ADDENDUM NO. 2

To: Bidders
From: Jerry Goff, AIA
Date: October 29, 2012
Re: Farmers Bank Operations Center Renovation
Pomeroy, OH

HOLLOW METAL JAMB DETAIL
 SCALE: 1 1/2" = 1' - 0"

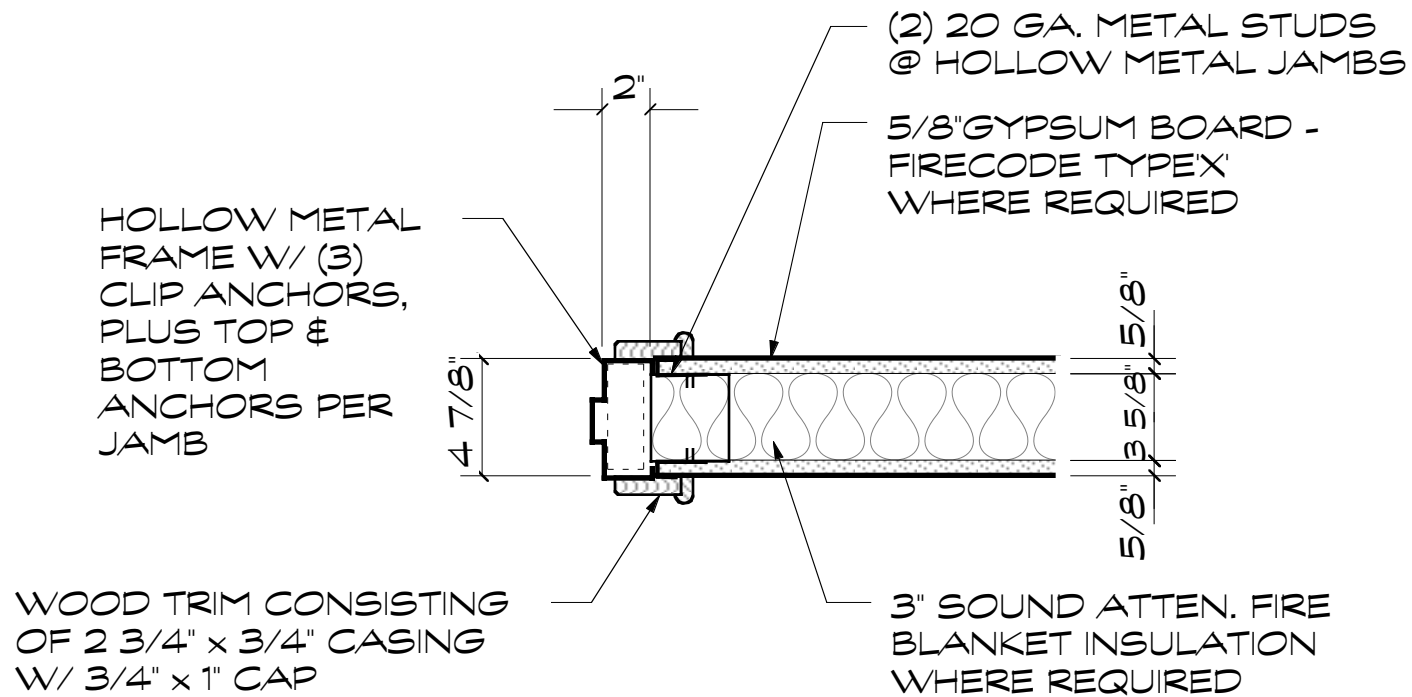
Drwg. A-5

1. ADD wood trim as indicated on attached Door Frame Detail "Hollow Metal Jamb Detail"
